Project Description: Fire Station #2 Replacement

RE: Change Order #2 **fully executed**

Work Changes Proposal Request No. 2

Project: 13117 Lexington Replacement Fire Station No. 2
City Job No. 161-2015/038-2016

SHEET: P-101A

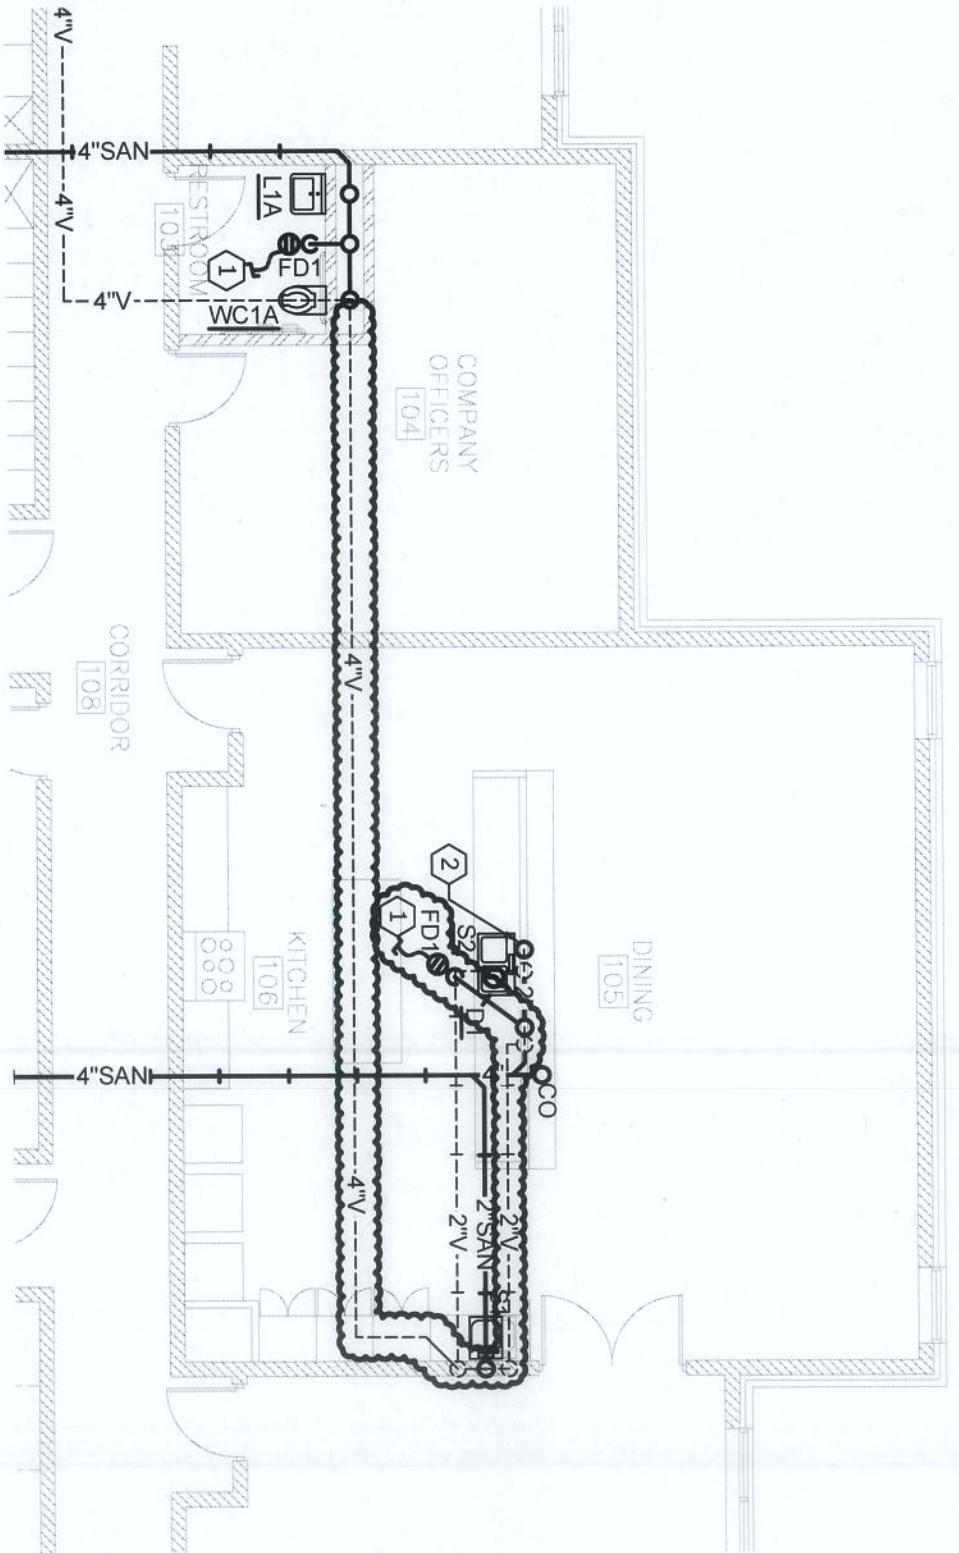
1. Per the Fire Department request, provide itemized pricing to add a floor drain to Kitchen 106 as shown in the attached **PR 2.1-PR 2.4**.
